**NEW SPENCER MIDDLE SCHOOL**

**ADDENDUM #6**

**July 20, 2022**

**THRASHER PROJECT #060-10259**

**A4.03**

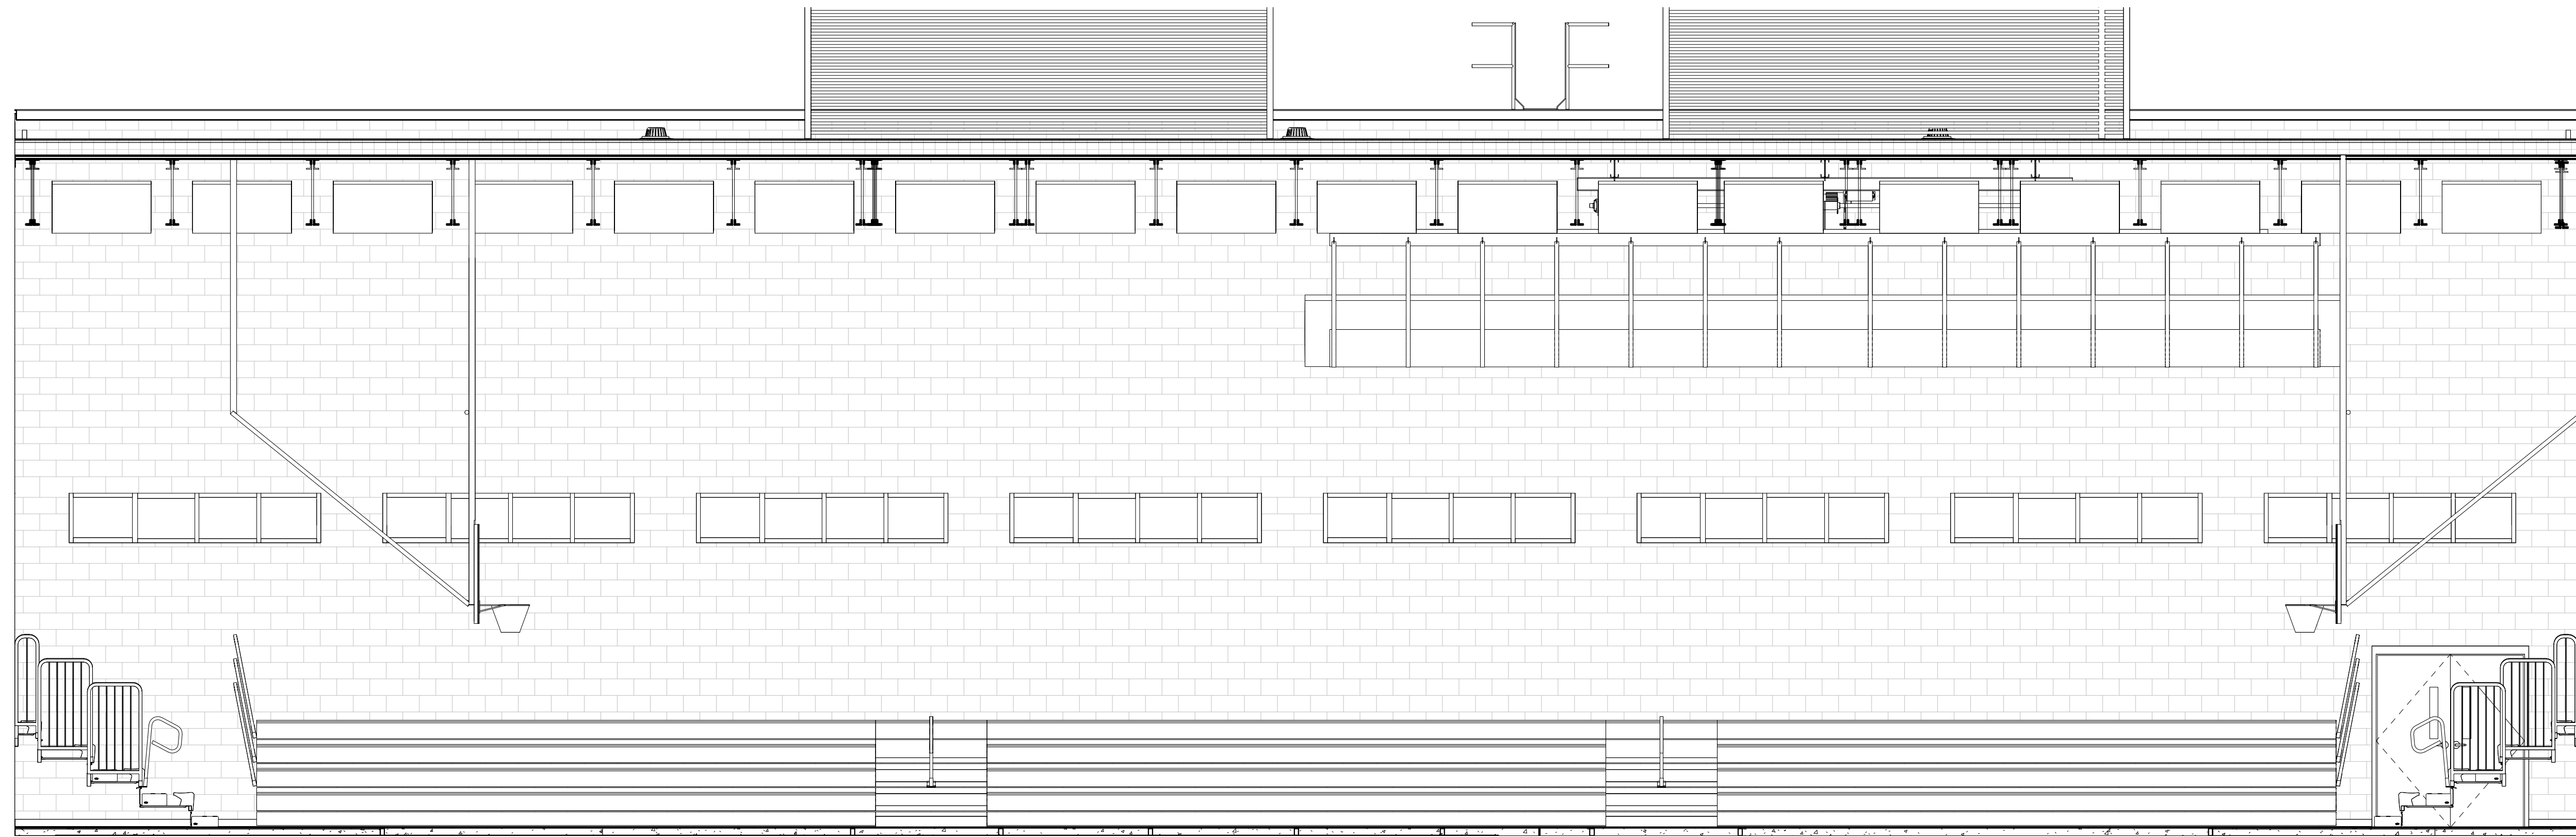
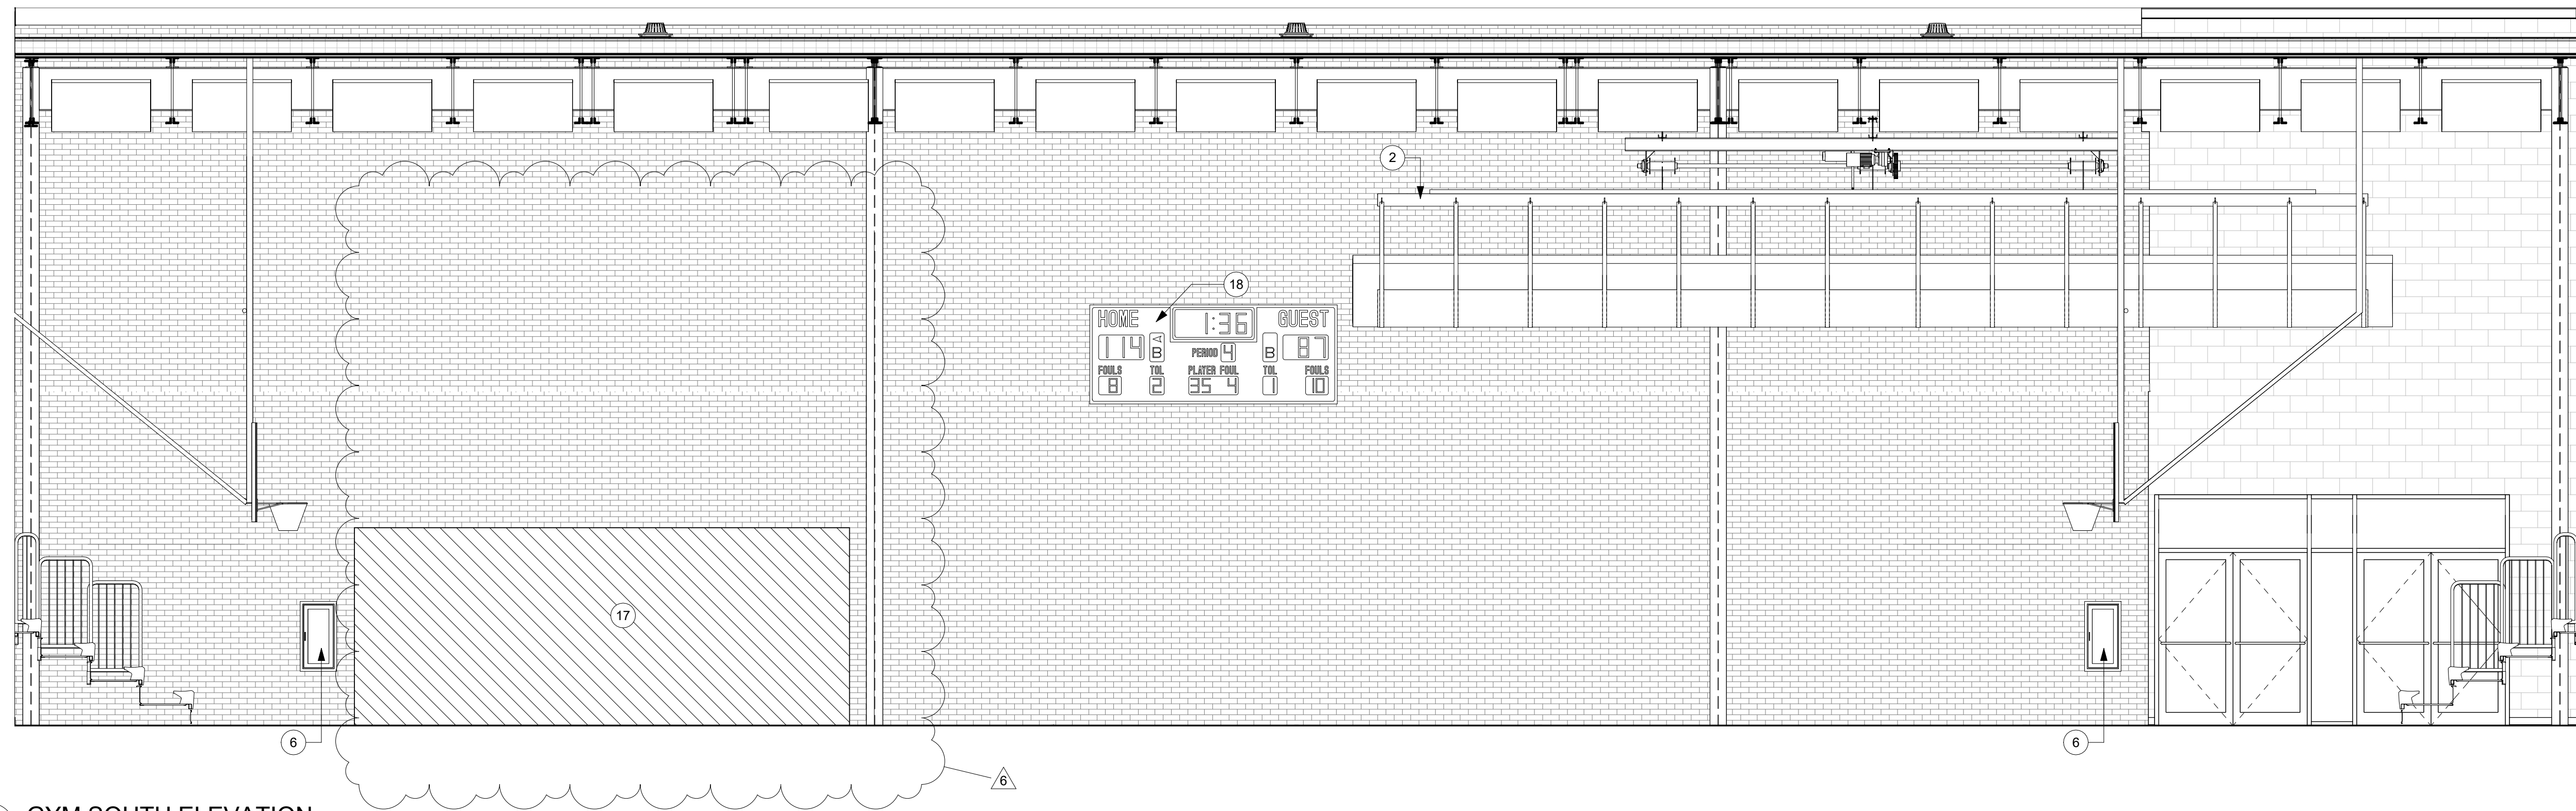
6. Revised drawings from Addendum 4, Questions 23 and 24 does not answer questions. Please provide Elevations on walls opposite of 12/A4.03 and 10/A4.03.

Elevations added in this addendum.

**A4.06**

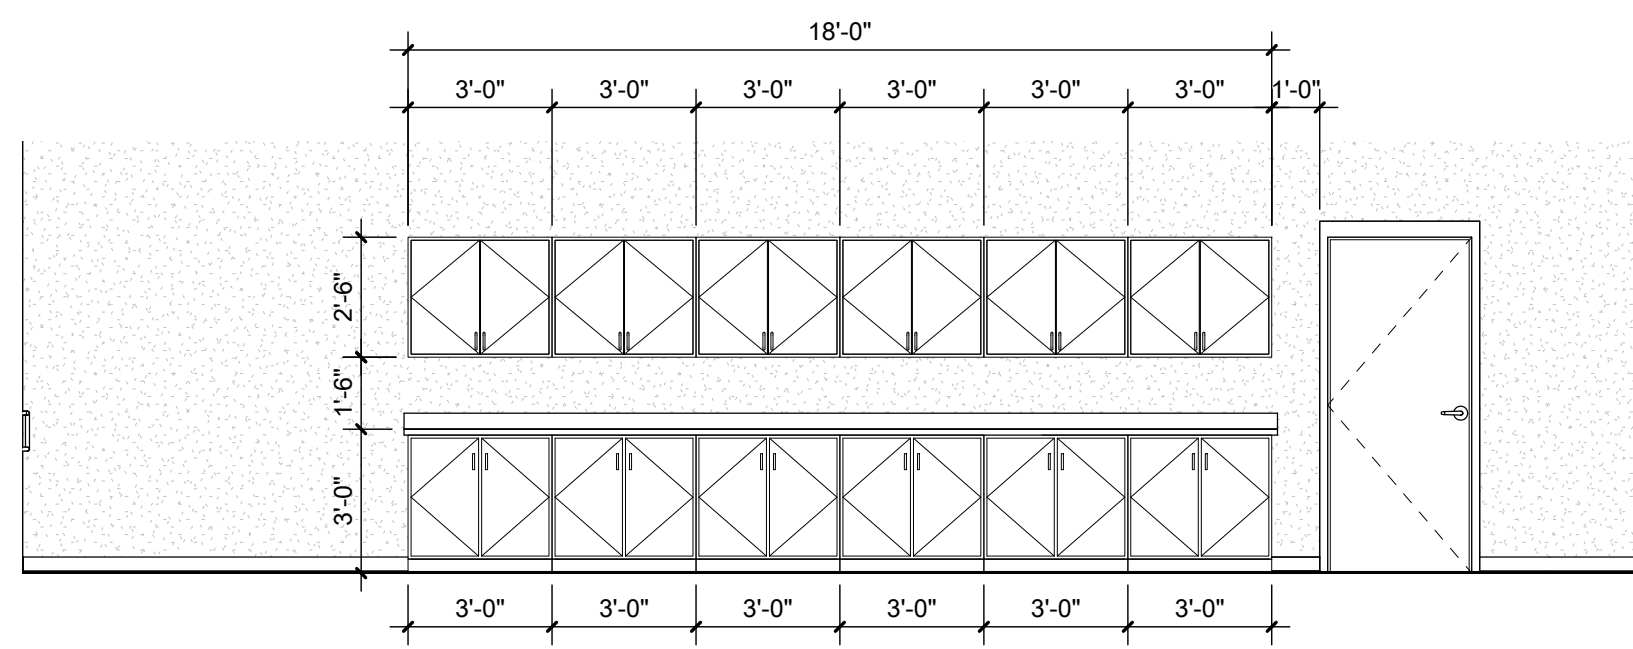
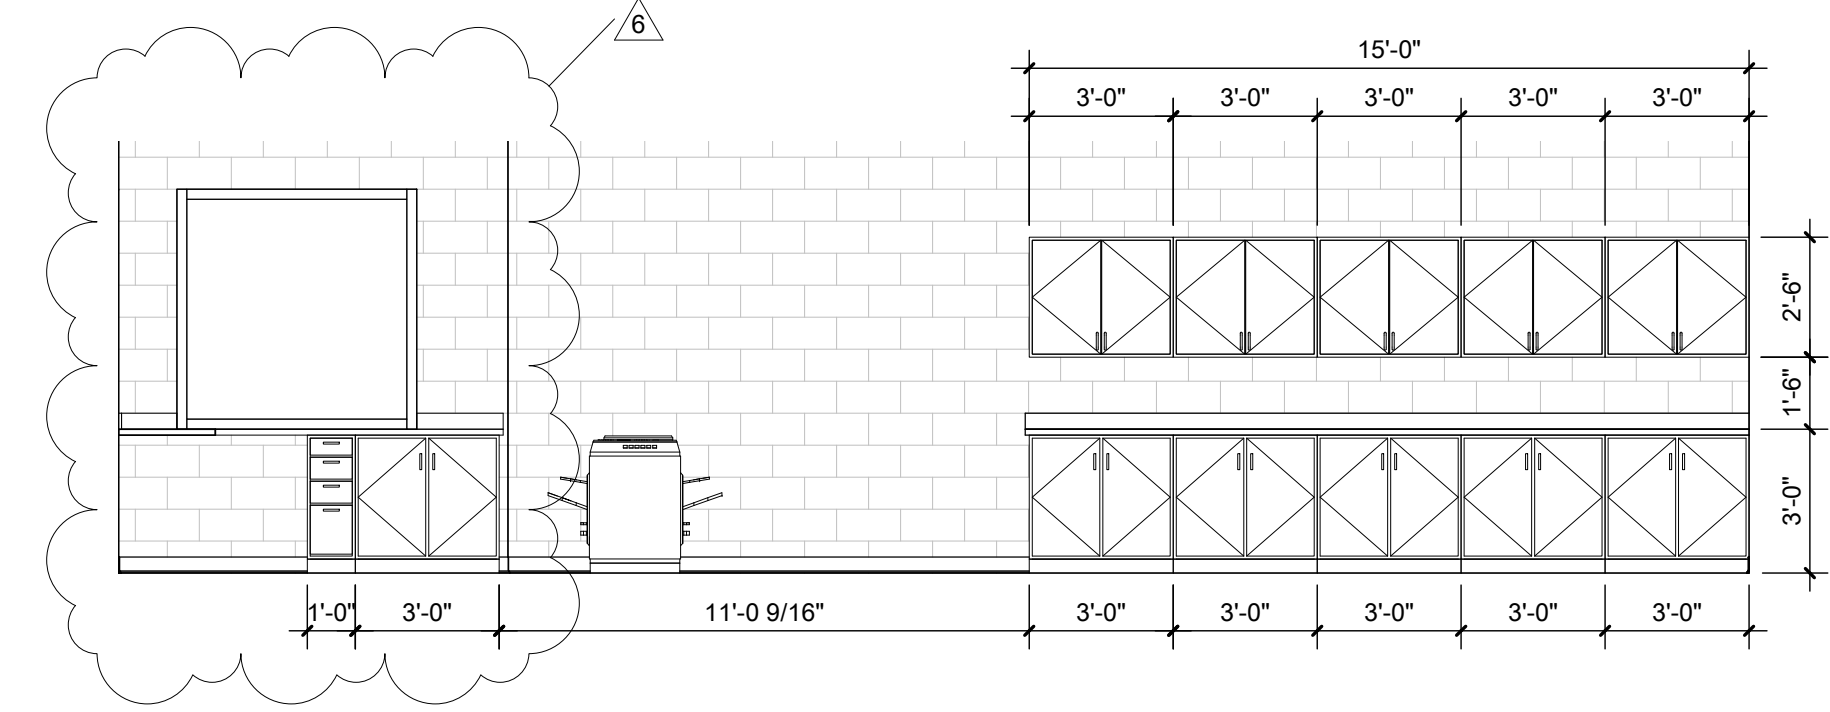
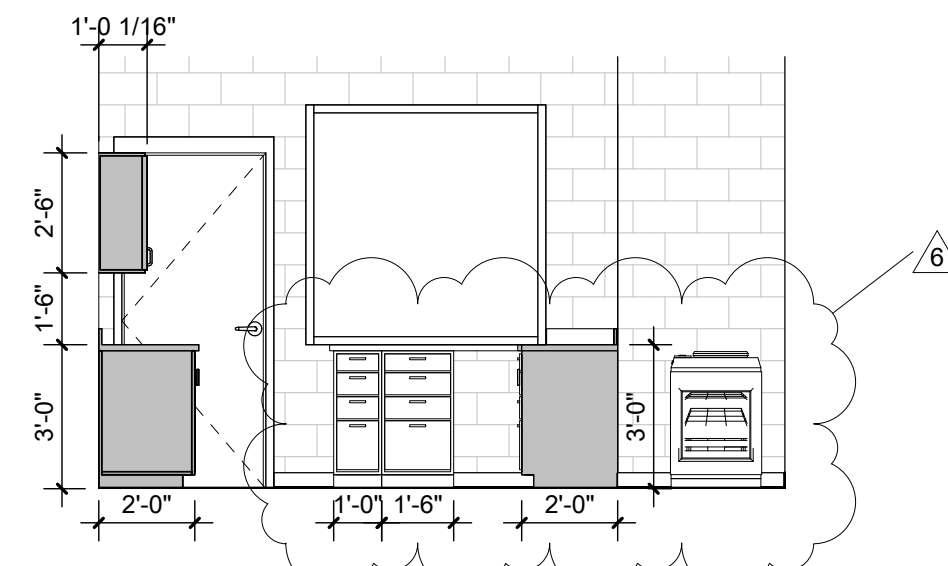
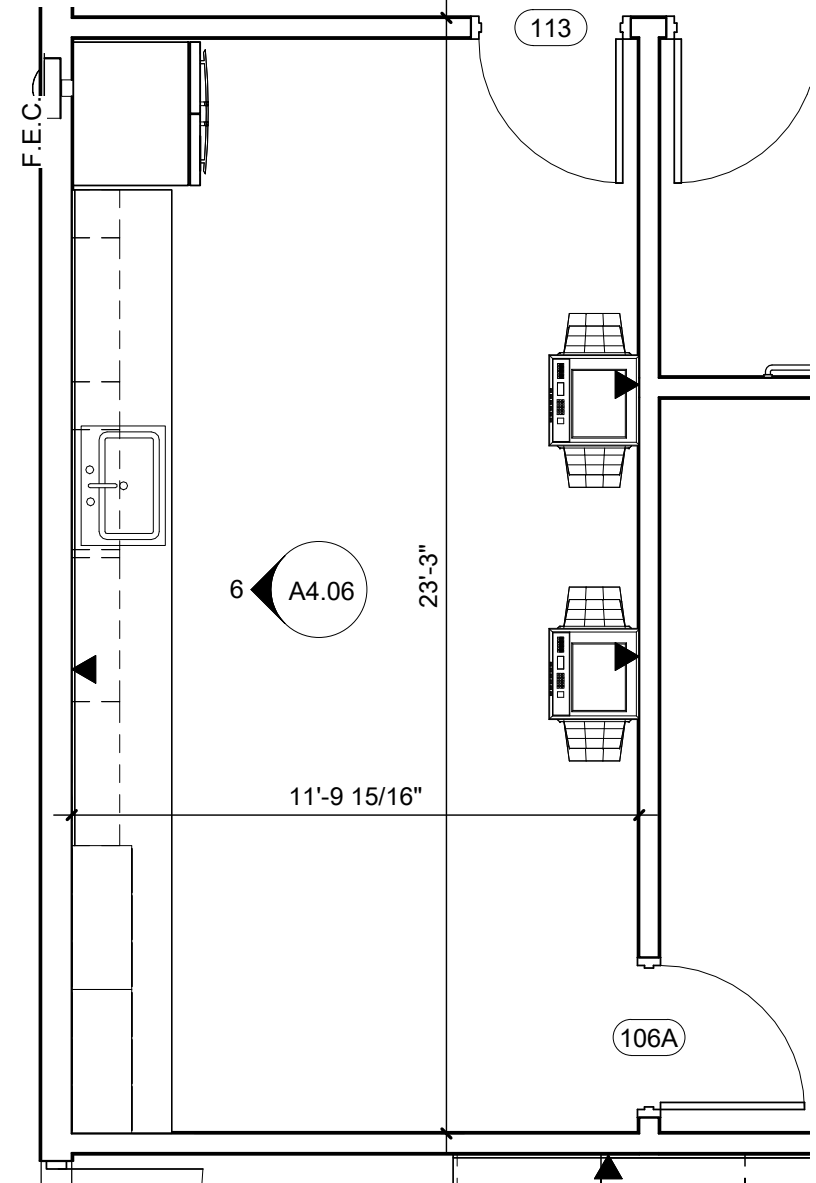
4. Revised Drawing A4.06 not included in Addendum 4 as Responded to Question 1.

Drawing revised in this addendum.
